<b>Title – Titre</b> One (1) Surface Grinder – Rectifieuse plane	<b>Solicitation No. – No de l'invitation</b> W8486-249310/A
<b>Date of Amendment – Date de la modification</b> 14 November 2023 – 14 novembre 2023	
<b>Address Enquiries to: – Adresser toutes questions à :</b> Martin Verrier <a href="mailto:Martin.Verrier@forces.gc.ca">Martin.Verrier@forces.gc.ca</a>	
<b>Telephone No. – No de telephone</b> 343-598-6884	<b>FAX No. – No de fax</b> N/A
<b>Destination</b> Quality Engineering Test Establishment 45 Sacré-Cœur Blvd, Gatineau, QC J8X 1C6  Centre d'essais techniques de la qualité 45, boul. Sacré-Cœur Gatineau (Qc) J8X 1C6

## **Amendment 002**

Amendment 002 to this Request for Proposal (RFP) is to provide answers to questions received and make the following changes to the document:

Figure 3-3 Electrical Power Source Connections

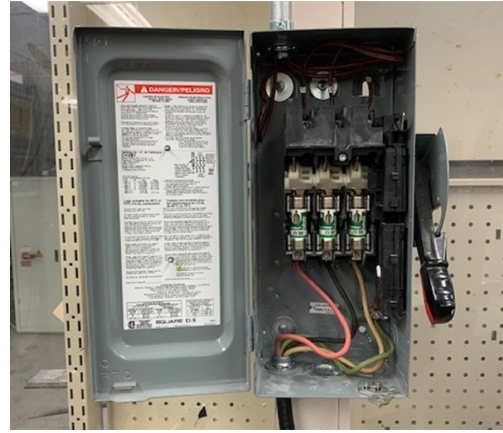
- (b) 575 VAC / 3 Phase / 60 Hz, 30 amps power supply.
- 3.1.13.2 The machine must have a disconnect box mounted on a nearby wall or column that complies with all applicable codes. The box shown in Figure 3-3 for the 208 VAC power supply is a temporary installation and must be replaced with an appropriate disconnect box supplied by the Contractor if this power supply is used. If the 575 VAC power supply is used, then the Contractor may use the existing disconnect box for this power supply as shown in Figure 3-3 or the Contractor may use another disconnect box that the Contractor delivers under the Contract.
